49 CFR Part 571

[DOT Docket No. NHTSA-98-4463]

Federal Motor Vehicle Safety Standards; Metric Conversion

ACTION: Final rule, technical amendments; response to petition for reconsideration.

Figure 1-LOCATION OF TEN CONVEX MIRROR TESTING POSITIONS All dimensions in millimeters (mm)

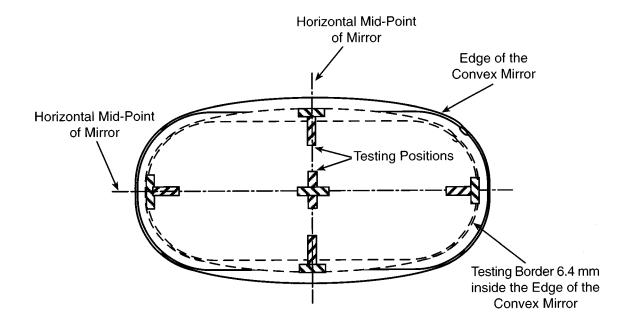
Dial Reading to Radius of Curvature". Ford noted that in Figure 1, the measurement "1/4" should be 6.4 mm to be consistent with S12.3 of Standard No. 111.

6. Section 571.111 is amended by revising in S12.8, Figure 1 to read as follows:

Figure 1
All dimensions in millimeters (mm)

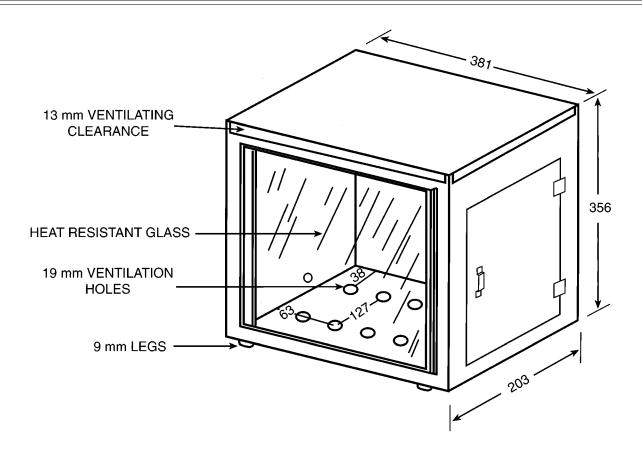
Standard No. 302, Flammability of interior materials—Toyota noted that S5.1.1 states: "each hole 19 mm in diameter". However, the diagram in Figure 1 has an 18 mm diameter dimension. Toyota stated its belief that the 18 mm diameter dimension in Figure 1 is incorrect and that NHTSA intended 19 mm.

13. In § 571.302, Figure 1, after S5.1.1, is revised to read as follows:
